Identification cards — Test methods — Part 1: General characteristics

AMENDMENT 1

Reference number
ISO/IEC 10373-1:2006/Amd.1:2012(E)

Amendment 1 to ISO/IEC 10373-1 was prepared by Joint Technical Committee JTC1, *Information technology*, Subcommittee SC 17, *Cards and personal identification*.

Figure Amd.1-1 — ICC-holder

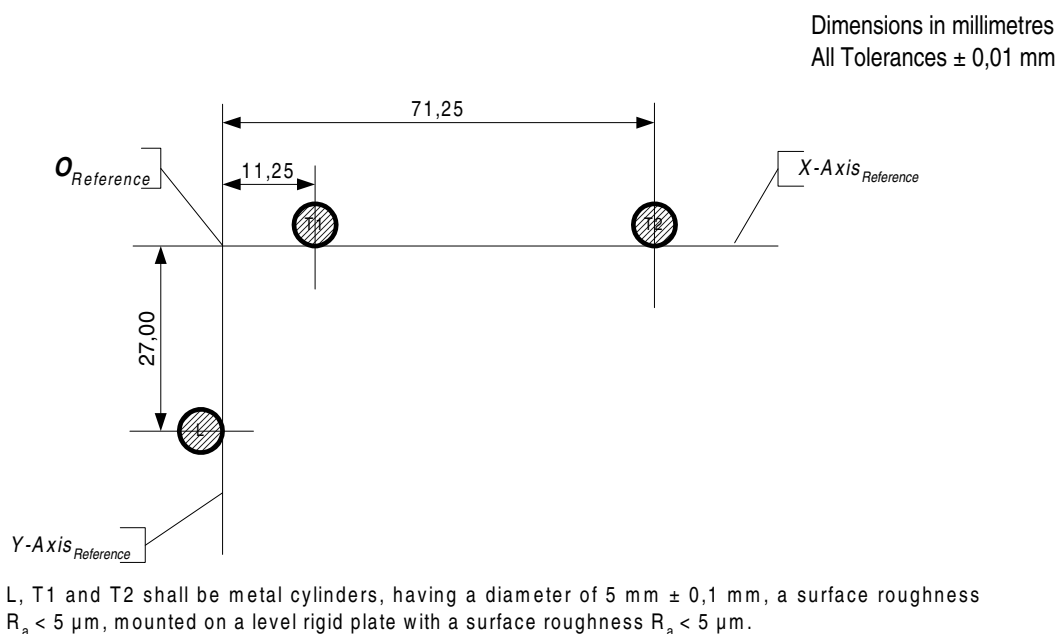
4.7.2 Default ICC-holder and reference axes:

The default ICC holder shall comply with Figure Amd.1-1:
